Building Permit Application

Permit No.: B16002101

Building Address: 5307 Catalpa Ct
 City: Ellicott City State: Md Zip Code: 21072
 Suite/Apt. # _____ SDP/WP/BA #: _____
 Census Tract: _____ Subdivision: Palmer Creek
 Section: _____ Area: _____ Lot: 98
 Tax Map: 0028 Parcel: 0049 Grid: 0011
 Zoning: _____ Map Coordinates: _____ Lot Size: 33547

From: Freemon, Robert [<mailto:rfreemon@howardcountymd.gov>]
Sent: Wednesday, May 25, 2016 4:18 PM
To: LaToya.Tilghman@whihomes.com; Dave Harward, III
Subject: 5307 Catalpa Ct., Building Permit

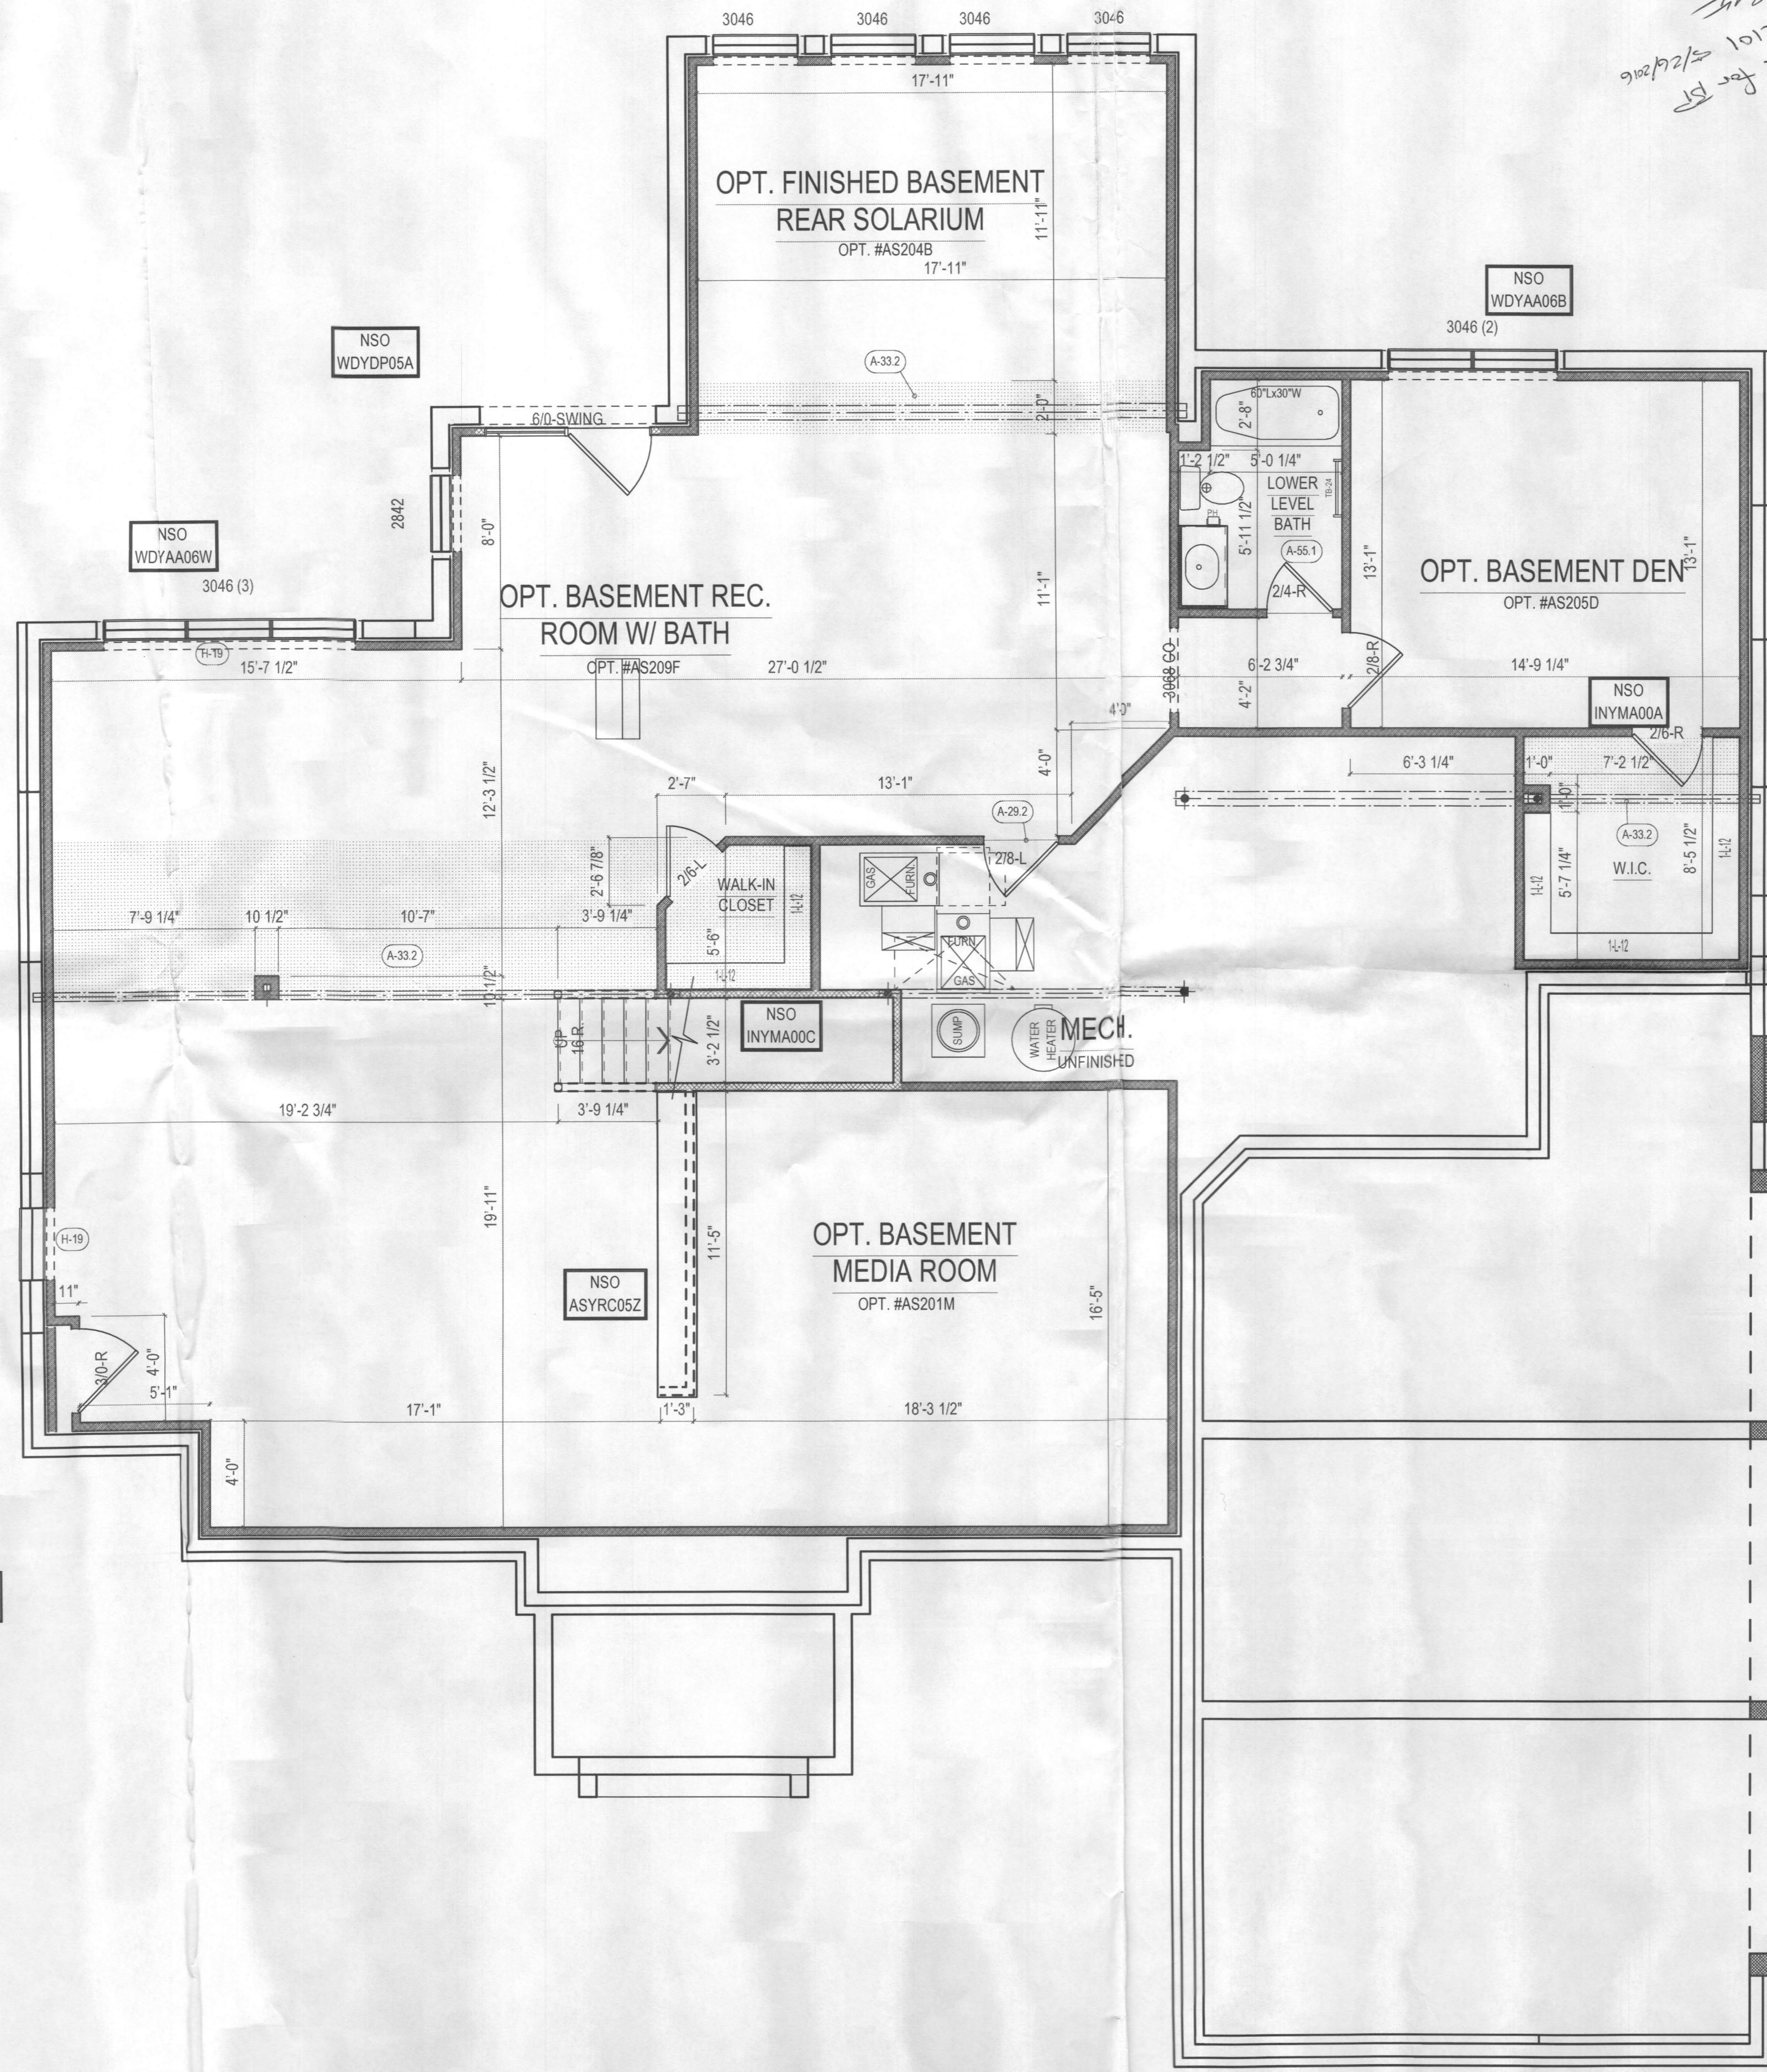
I have reviewed the building permit (B16002101) for 5307 Catalpa Ct. and have a couple of comments. The SHC line needs to be sleeved underneath the driveway and its invert elevation into the house corrected (not 336.5 ft). Also the well certification statement needs to be corrected (not HO-95-1383). Is there going to be a basement interior ejector pit connection to the SHC line? Also is the grinder pit elevation (434.60 ft) field verified? Let me know if you have any questions.

Thank You for your review. Attached is a revised Permit Site Plan. The sleeving detail and note on the plan to provide it under the driveway for the SHC has been added. Also the invert at the house and the well tag no. corrected.

There is a note on the plan that essentially states that an ejector is required and the builder is fully aware of that (note read "basement will not sewer by gravity"). The invert at the grinder pump has been field verified. If you need new prints delivered to your office, please let me know (the attached prints out on a 11"x17" size sheet to have it scale correctly).
